Subject: ROUGH IDLE, LACK OF POWER, AND/OR MIL ON WITH DTC P2177/P2187 (FUEL SYSTEM LEAN)	Bulletin No: 01-022/08
	Last Issued: 04/02/2008

This bulletin supersedes the previous bulletin issued on 03/27/08. The REPAIR PROCEDURE has been revised.

Date of production is marked as a 4 digit code “YMDD” at the pipe.

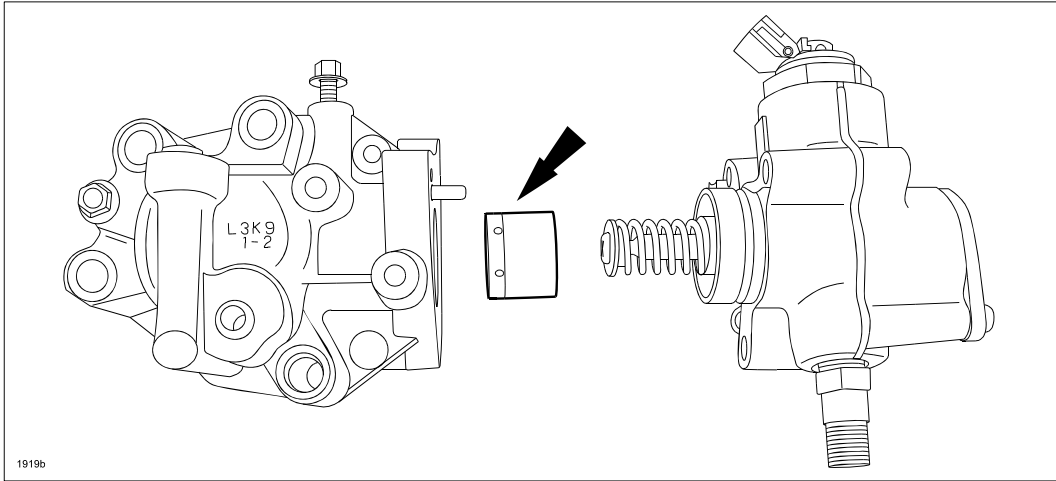
- If the history indicates part number L3K9-13-35ZB was used during a repair, use the following illustration to inspect the production date of the high-pressure fuel pump. Replace it if the production date is before March 26, 2007.

Y for Year	4 for 2004....7 for 2007
M for Month	1 for Jan....9 for Sept, X for October, Y for Nov, Z for Dec
DD for Date	01 for 1st of month....31 for 31st of month
Example	“4Z16” means Dec 16, 2004; 7608 means June 8, 2007

CAUTION: When replacing the high-pressure fuel pump, it is very important to make sure that the tension collar is present before reinstalling the pump. Failure to do so will result in excessive engine noise and the subsequent failure of the high-pressure fuel pump and its cam lobes.
